UNITED STATES ENVIRONMENTAL PROTECTION AGENCY

21 November 2001

Re: **Conditional Approval of General Electric's April 2001 submittal *Baseline Monitoring Proposal for Plant Site 2 Groundwater Management Area (GMA-3), General Electric (GE) Housatonic River Project Site, Pittsfield, Massachusetts.***

**FIGURE 1
PROPOSED GMA3
MONITORING LOCATIONS**

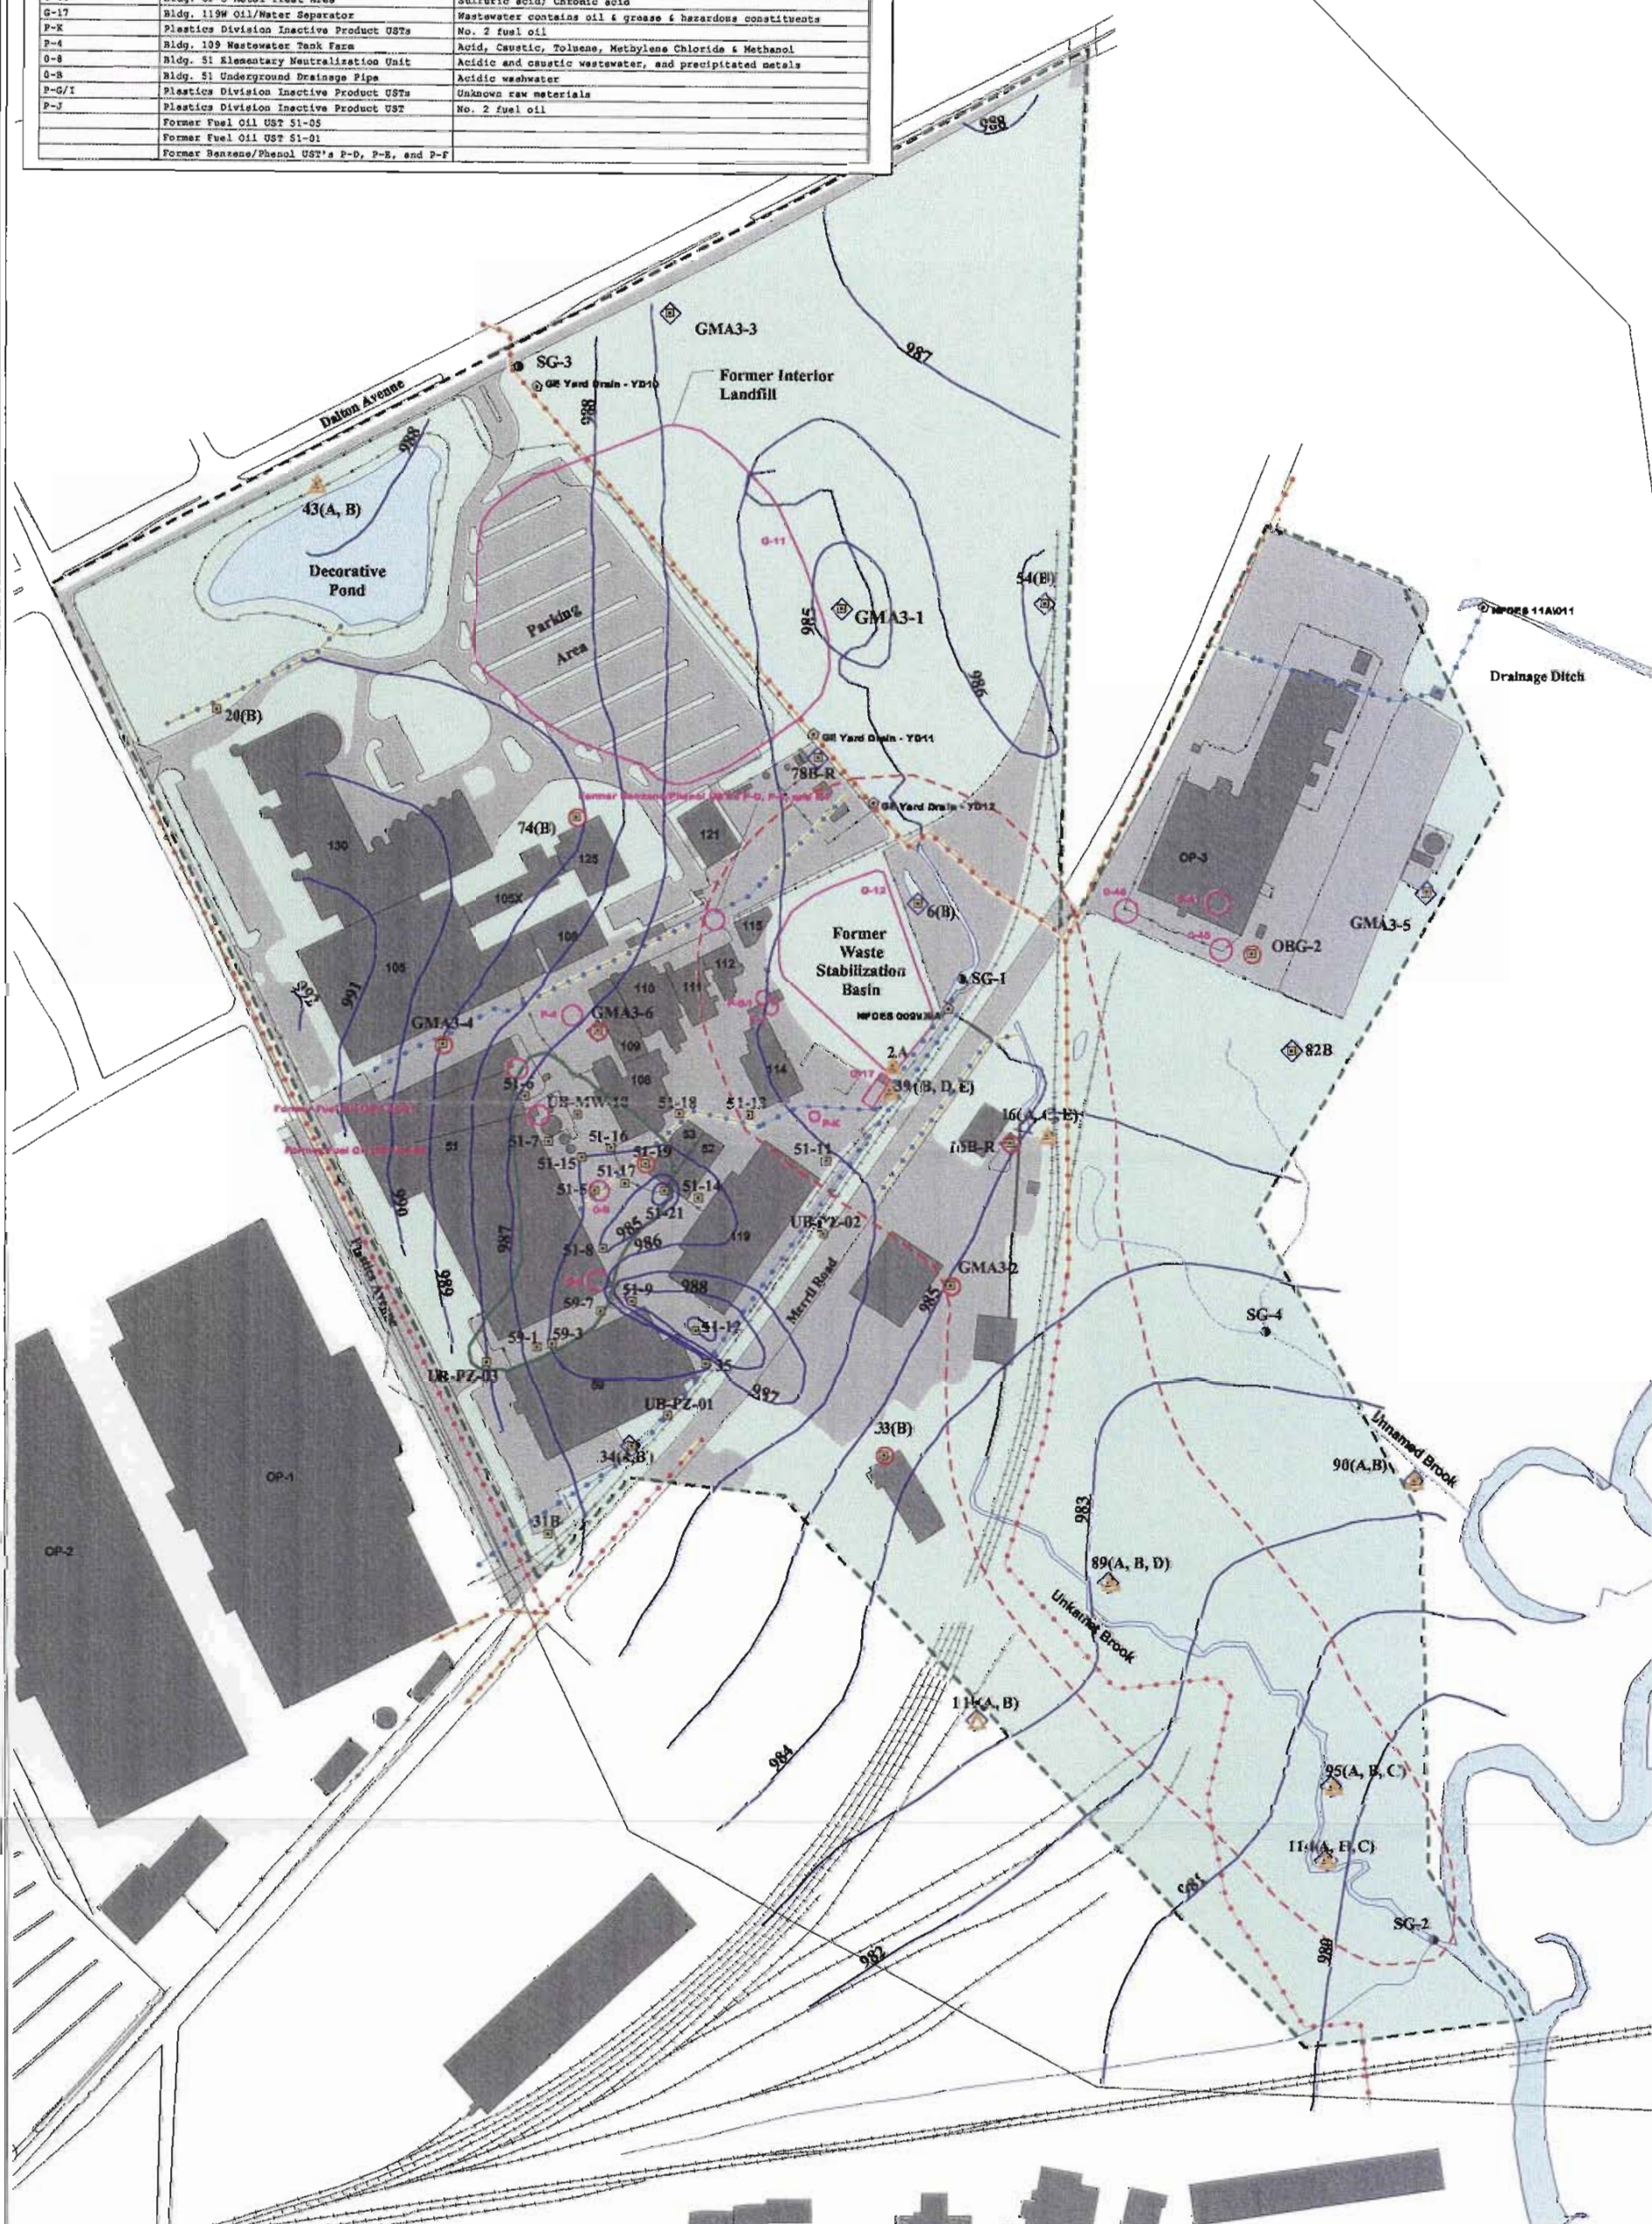
4. GE's proposed GMA-3 baseline monitoring well network requires several modifications. GE shall conduct the GMA-3 baseline monitoring activities at the locations listed in Table 1, which are depicted on Figure 1 and listed below:

- a) EPA does not concur with GE's proposed replacement of GW-2 compliance well OBG-2 with well OBG-1. GE shall utilize OBG-2 as a GW-2 compliance well.

- b) Three additional GW-2 compliance wells shall be added to properly monitor occupied buildings in GMA-3:
 - GMA3-2 - South of Merrill Road near the location of abandoned well 57. The two nearby buildings need to be monitored, since the delineated extent of the VOC groundwater plume passes near or under the two buildings.

- GMA3-4 - Between Buildings 105 and 51, replacing well 27(B).
 - GMA3-6 - West of Building 109 next to the former Building 109 Wastewater Tank Farm.
 - c) One additional GW-3 upgradient perimeter well shall be added to the GMA-3

baseline monitoring program. GMA3-3, depicted on Figure 1, shall be located south of Dalton Avenue near the former location of abandoned well 46, replacing GW-3 perimeter wells 50B and 43B (which will be retained for groundwater level measurements, with wells 43A and 43B also retained as natural attenuation monitoring locations, as proposed).

- d) A GW-3 source area monitoring well, GMA3-6 (also listed above as a new GW-2 compliance well), shall be added to the Baseline Monitoring Program near the former Building 109 Wastewater Tank Farm, to provide source characterization data.

- e) Two additional GW-3 downgradient perimeter monitoring points, GMA3-5 and 82B, are required southeast of Building OP-3, to provide adequate groundwater quality and hydrologic coverage for the area.

9. GE shall install an additional staff gauge along Unkamet Brook and another on the unnamed brook south of Building OP-3 (former Unkamet Brook channel), for

inclusion in the quarterly groundwater elevation monitoring. The two additional staff gauge locations are depicted on Figure 1 and are listed below:

- Upper Unkamet Brook – at Dalton Avenue (SG-3)
- At the confluence of the unnamed brook and its tributary – north-northwest of well cluster 90 (SG-4).
